A585 Windy Harbour to Skippool Improvement Scheme

TR010035

7.11 Environmental Statement Changes and Corrections Document

Environmental Statement Changes and Corrections Document

Status	DEADLINE 2 SUBMISSION	Revision	1
Scale	1:2500 A3	Date	MAY 2019
Drawn By	J.NORMAN	Checked By	K.BURROWS
Approved By	N.HENDERSON	PINS No.	TR010035
Drawing number	HE548643-ARC-EGN-SZ_ZZ_000-DR-LE-30	FIGURE	FIGURE 11.4

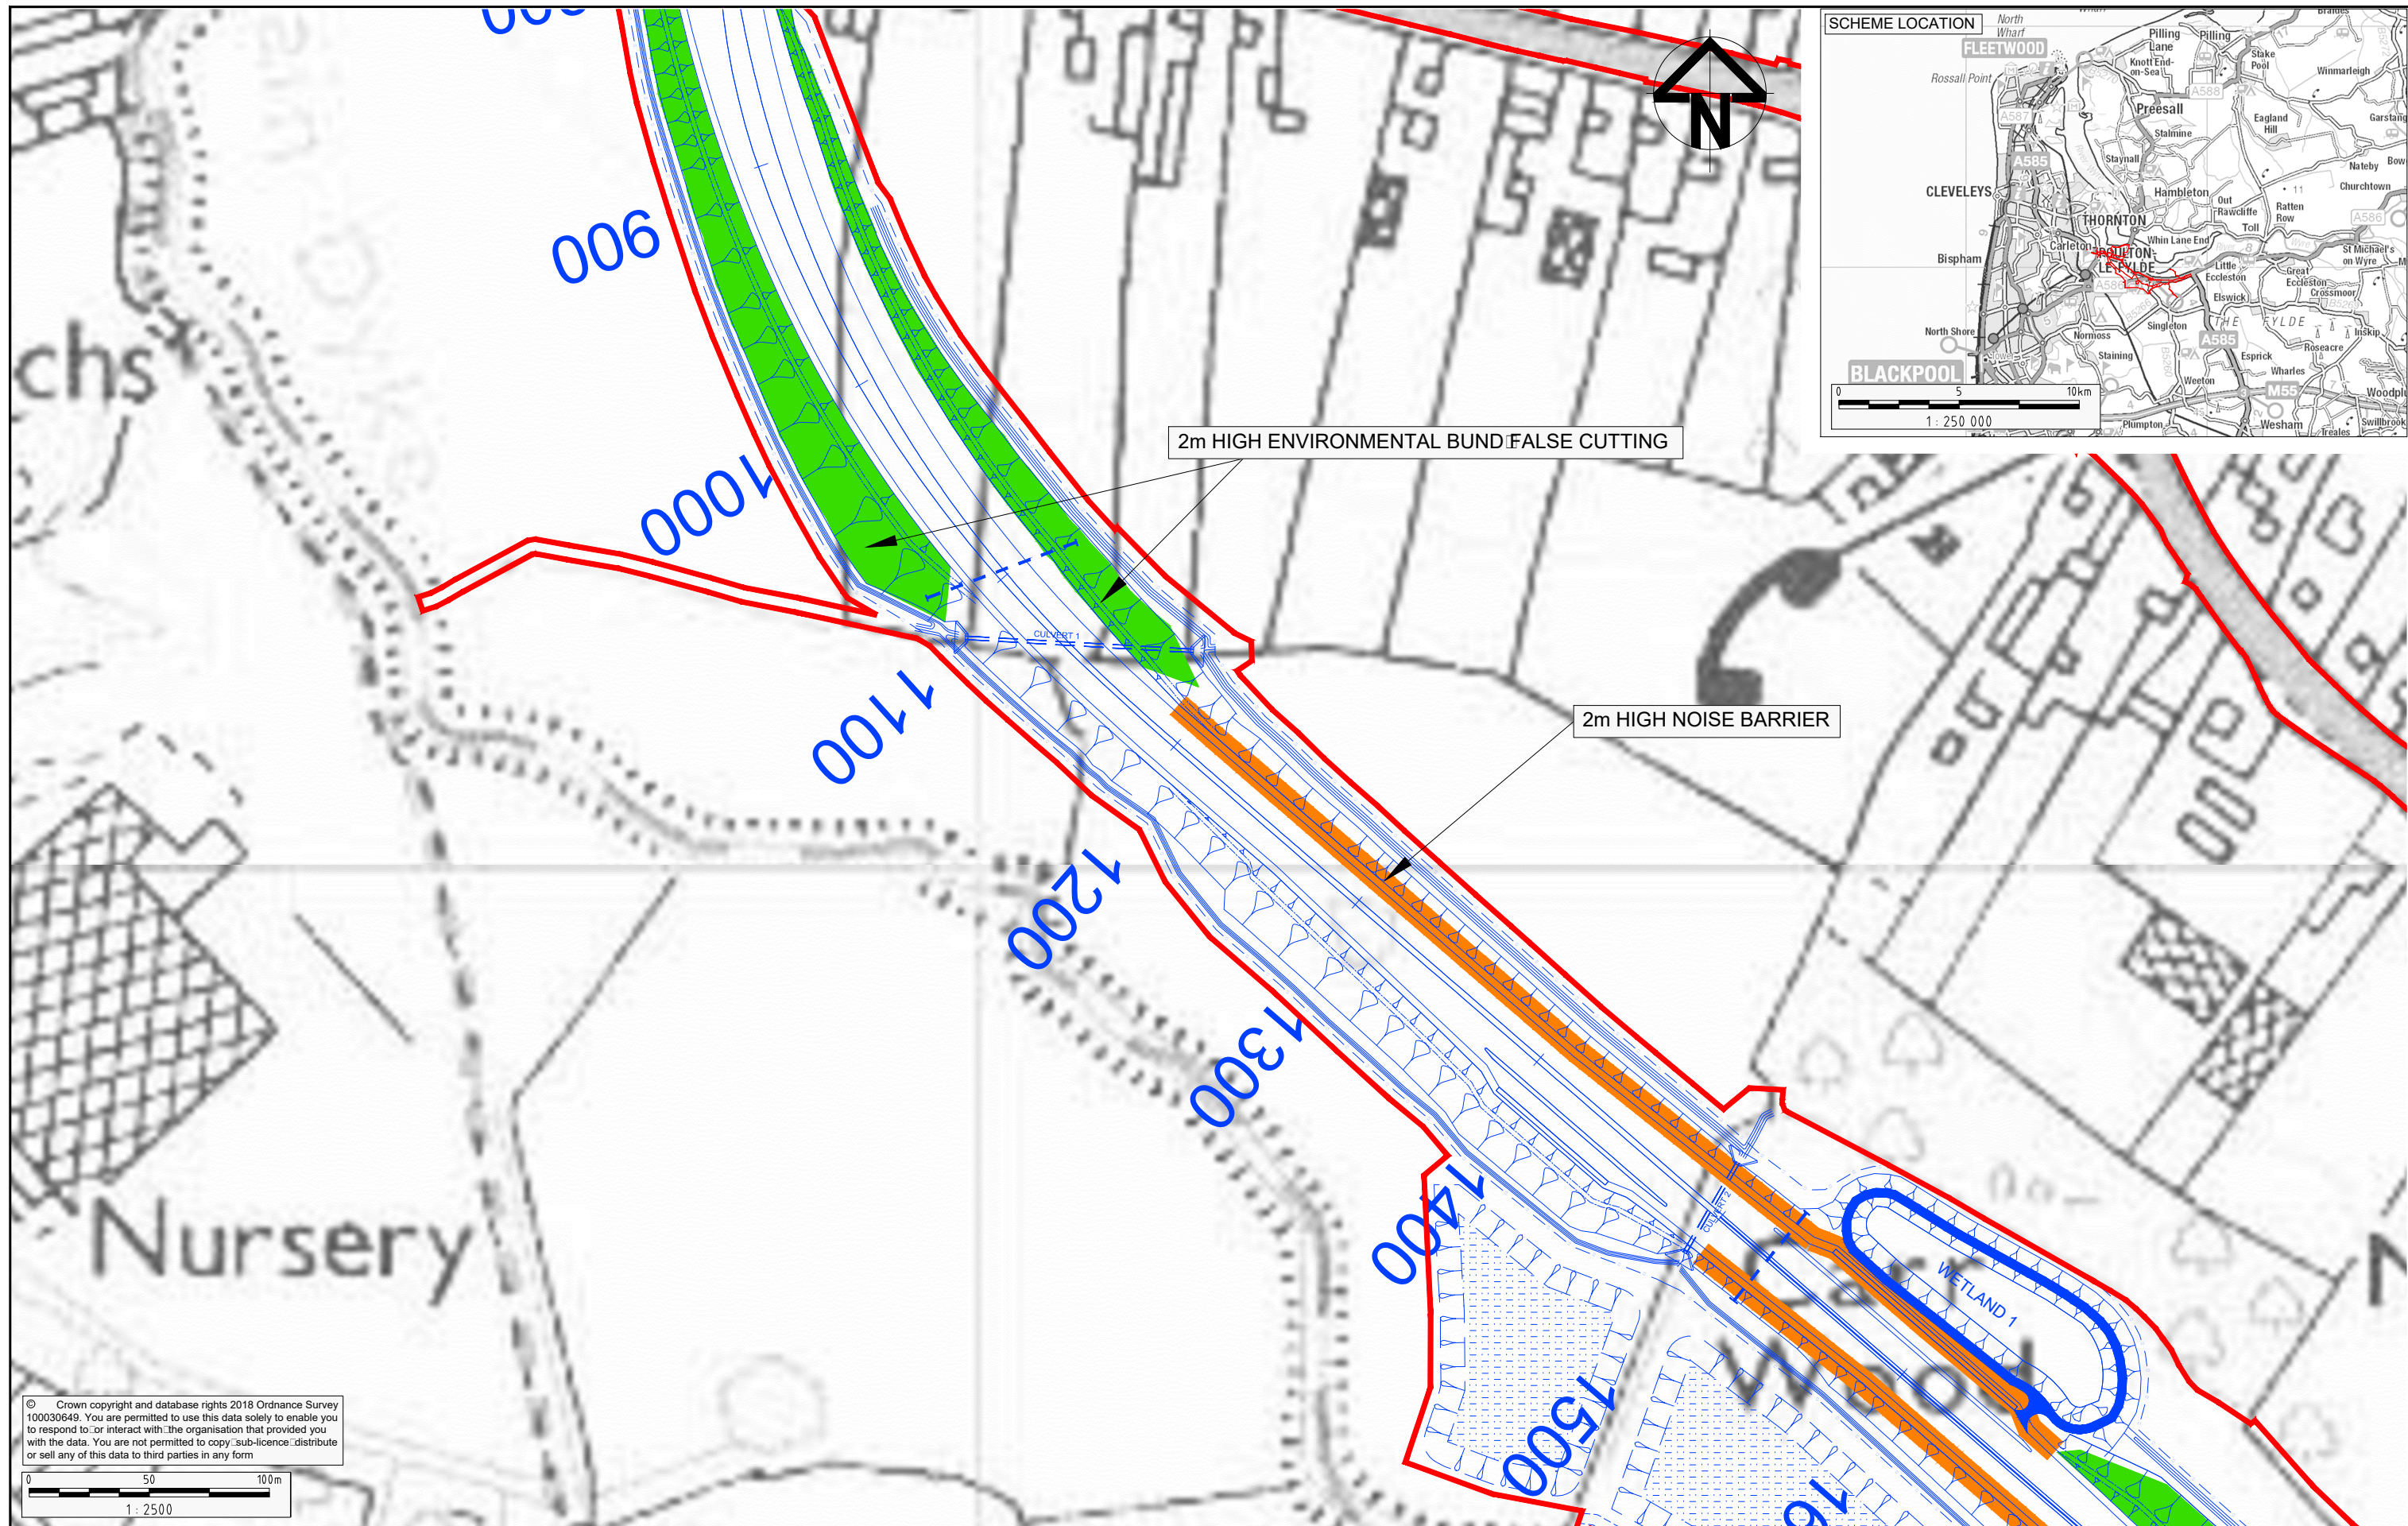
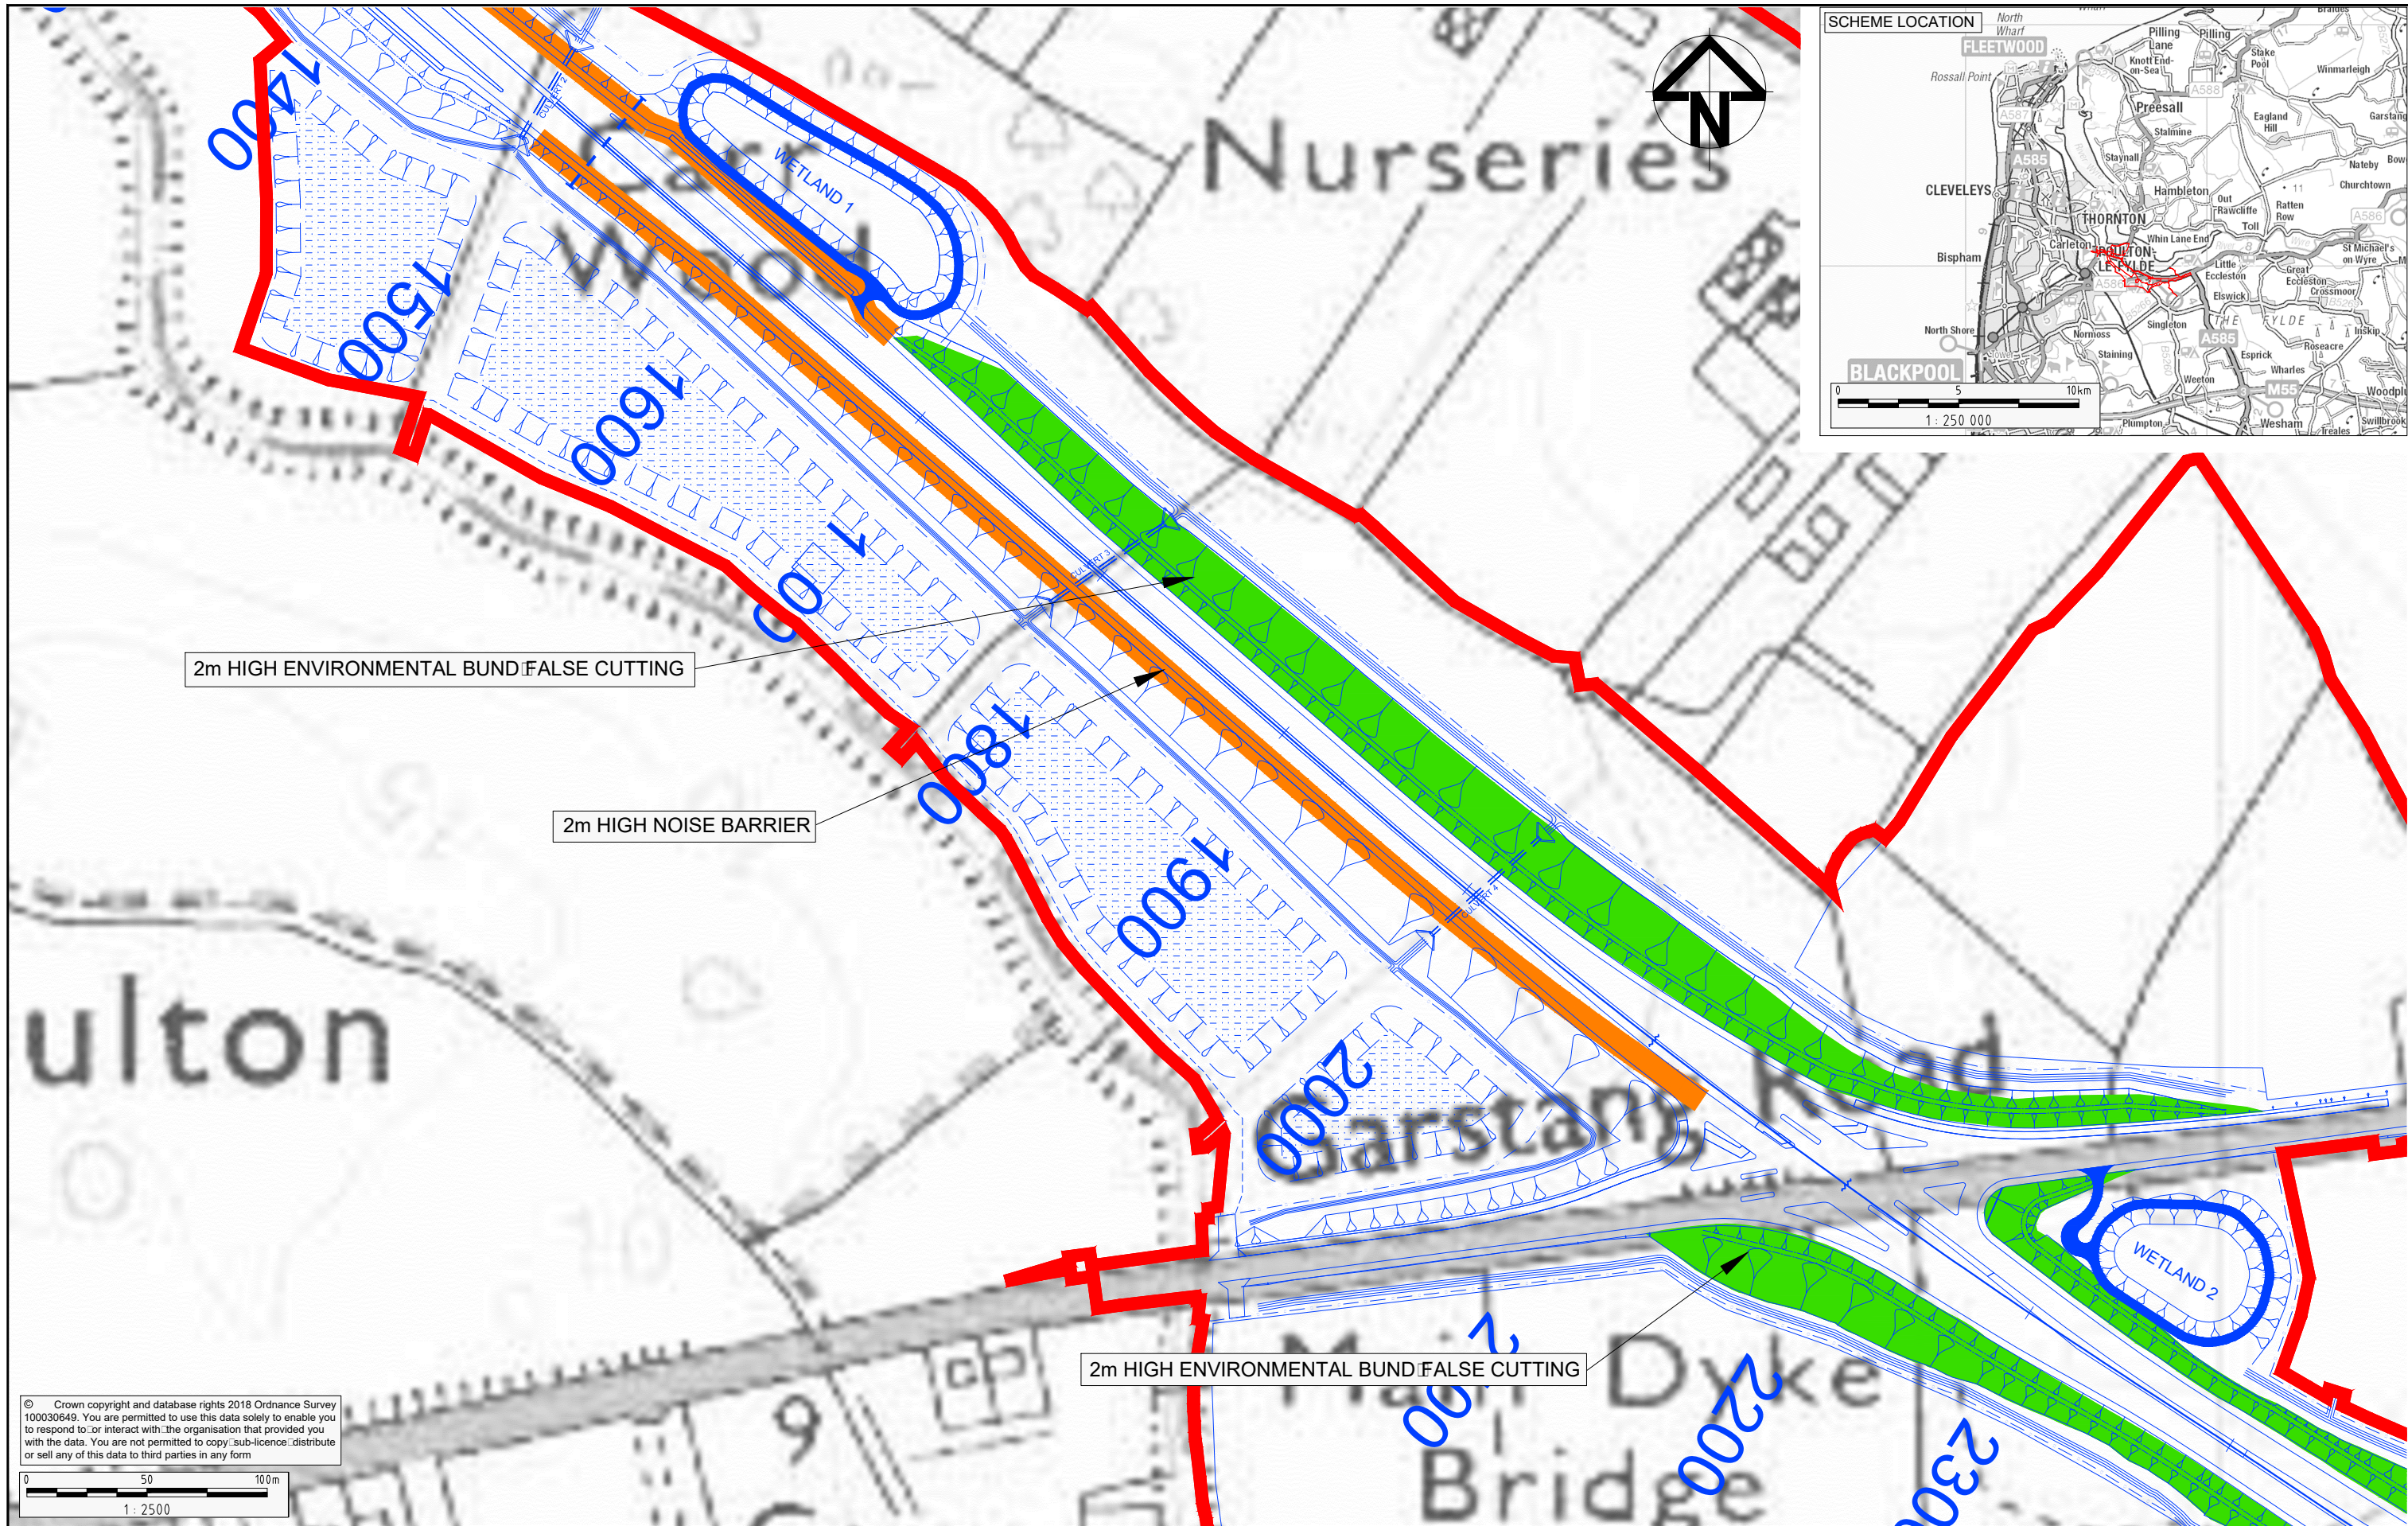
Document Reference Number	Document Name	Amendment Required	Reason
			TR010035/APP/7.10).
6.11	ES Chapter 11: Noise and Vibration	Update to Figure 11.4: Noise and Vibration – Noise Mitigation within the Study Area presented at Appendix D to show heights and locations of earth mounds and acoustic fencing at a larger scale.	Requested by the Inspector within the first round of written questions (document reference TR010035/APP/7.10).
